APPLICANT'S RESPONSE TO THE DEADLINE 2 SUBMISSIONS

FOR THE DEVELOPMENT CONSENT ORDER
APPLICATION FOR THE ALTERATION AND
CONSTRUCTION OF HAZARDOUS WASTE AND LOW
LEVEL RADIOACTIVE WASTE FACILITIES AT THE EAST
NORTHANTS RESOURCE MANAGEMENT FACILITY,
STAMFORD ROAD, NORTHAMPTONSHIRE

PINS project reference: WS010005

PINS document reference: 10.2

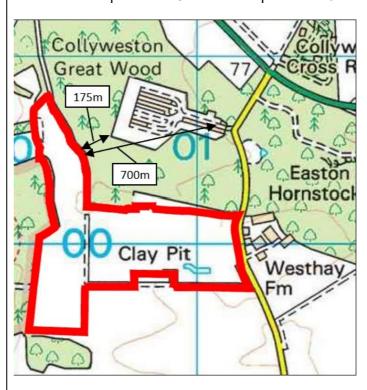
vibration	bomb store on its land to commercial storage use. This is the area edged in blue and	for general storage and distribution use (Use Class B8) in 2009. Planning application reference

coloured white in the centre of the wood on the plan at Appendix 1. The Trust has a revised planning application pending a decision at the moment to remove some of the buildings. Once this is granted the Trust will look to secure a tenant and start using the site for storage. The alarm noises from reversing vehicles as well as vibrations on the Resource Management Facility could cause a disturbance both to those working in the converted bomb store and the fauna of the woodland, so appropriate noise mitigation measures need to be put in place.

NE/21/01459/FUL for the demolition of the existing buildings and structures at the site was submitted to North Northamptonshire Council in September 2021. The application has yet to be determined.

Separation Distance

As shown above at its closest point the proposed storage facility is located 175 m from the nearest operations within the proposed western extension. Much of the proposed storage facility is located at a greater distance than this with some areas of the proposed storage facility located in excess of 700m from the proposed western extension area at its closest point.

Noise reduction from sound power levels of plant and equipment over 175 m from point sources on the ground (e.g. tracked excavators and dozers) equates to 53 dB based on distance alone. Attenuation from air absorption, ground effects and topographic screening would provide additional reduction in noise levels from the proposed western extension and the existing ENRMF. The equivalent noise reduction over 700 m is 65 dB. Overall the proposed storage facility benefits from a good separation distance at which noise impacts from the proposed development will be minimal.

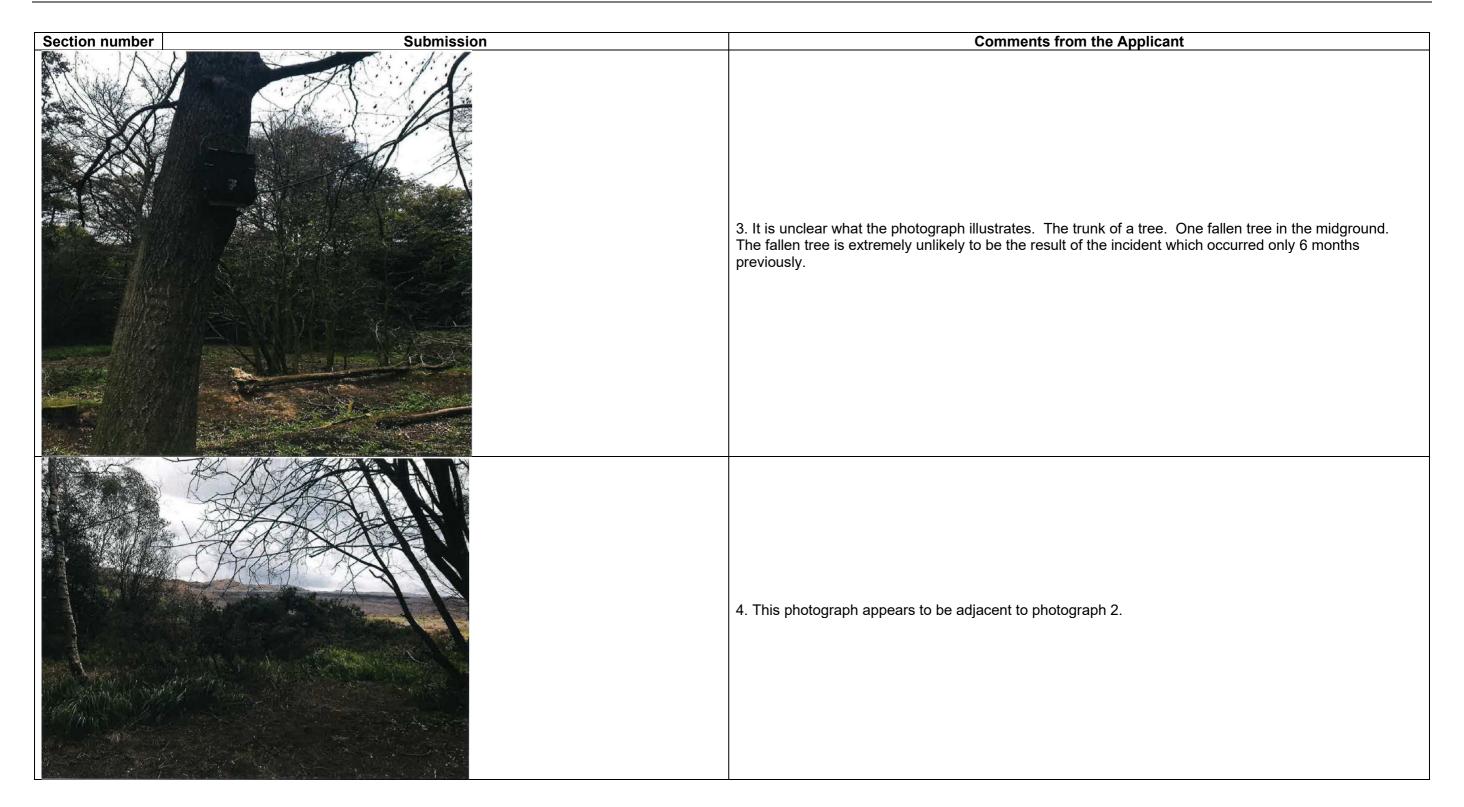
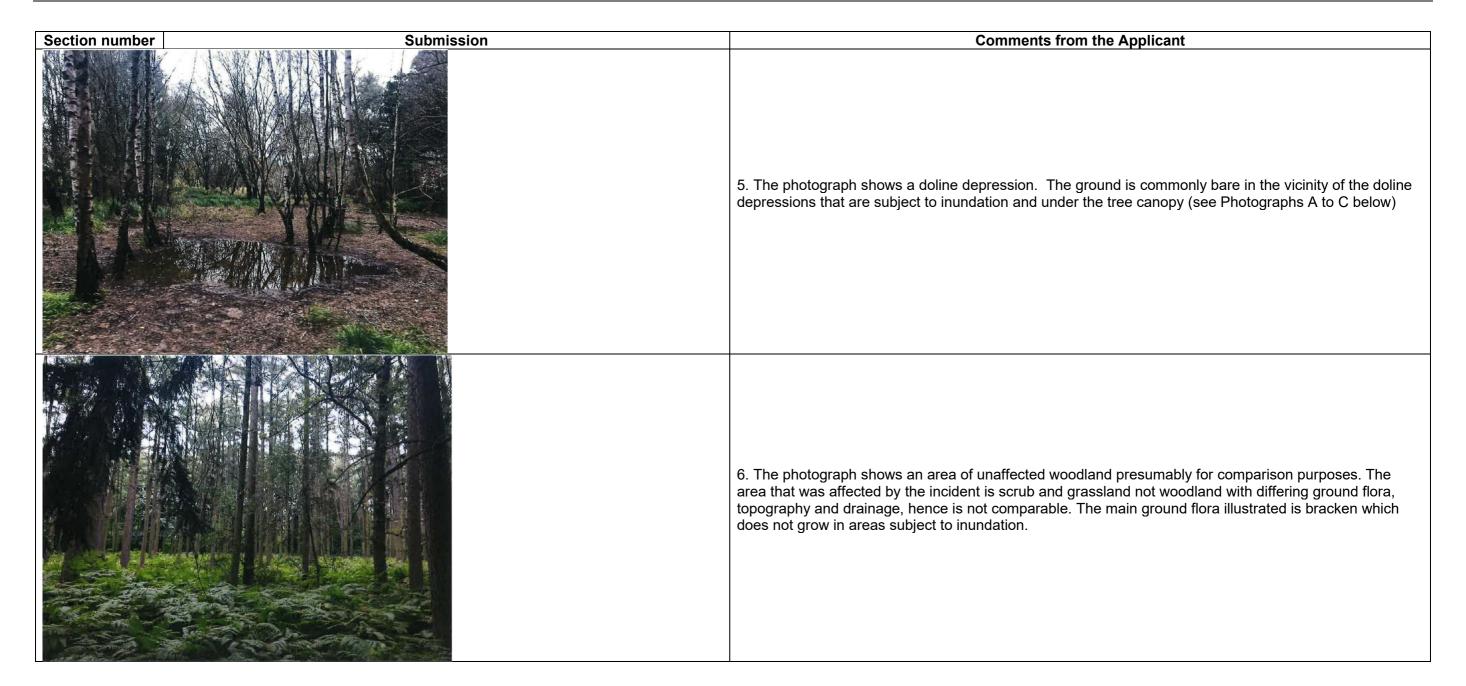
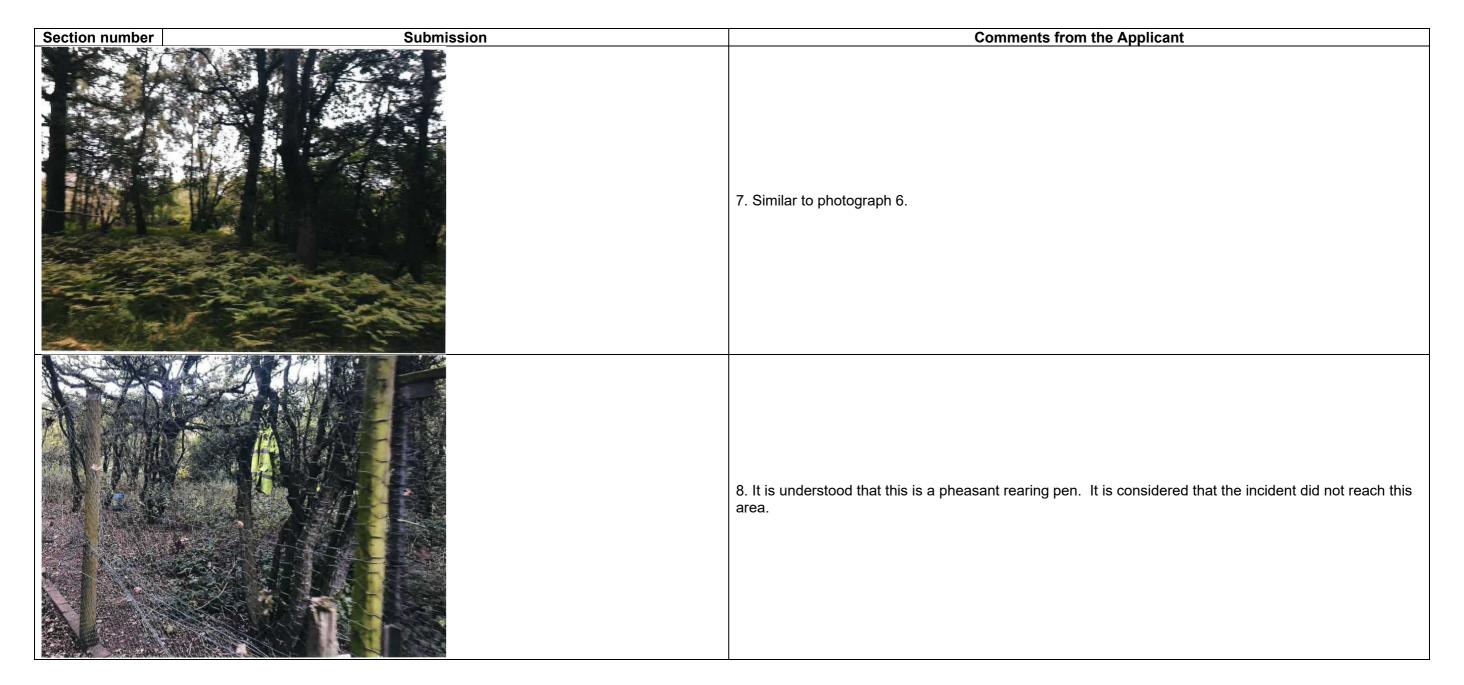
1. The photograph shows a ditch course to the left, that runs west to east, and an area of bare ground. The ditch courses in the woodland generally are not vegetated due to frequent inundation. The bare ground could be due to the incident or due to inundation or a combination of both. Loose vegetation and leaf litter was cleared from the ground shortly after the incident which also may contribute to the lack of vegetation.
		The photograph appears to be the edge of a doline depression. Many of these do not support vegetation as they are regularly inundated.

Section number	Submission	Comments from the Applicant
		9. The photograph shows a drainage channel. The ditch courses and drainage channels in the woodland and scrub are commonly unvegetated. (See Photograph D below)
		10. The photograph shows drainage channels. See comment on photograph 9. (See Photograph D below)

Section number	Submission	Comments from the Applicant
		11. The purpose of this photograph is unclear.
		12. The same photograph as 11.
		For comparative purposes a series of photographs taken by the Applicant of land to the west of the proposed western extension (this is land not owned by the CEFT or affected by the incident) in March 2022 are provided below:

Photograph A - Doline depression in the spinney to the west of the swallow hole showing a lack of vegetation in the depression

Photograph B – Doline depression in the woods to the west of the proposed western extension area showing a lack of vegetation in the depression.

Section number Submission Comments from the Applicant Photograph C – Doline depression in the woods to the west of the proposed western extension showing a lack of vegetation in the depression. Photograph D – Drainage channel in woodland to the west of the proposed western extension area showing a lack of vegetation.
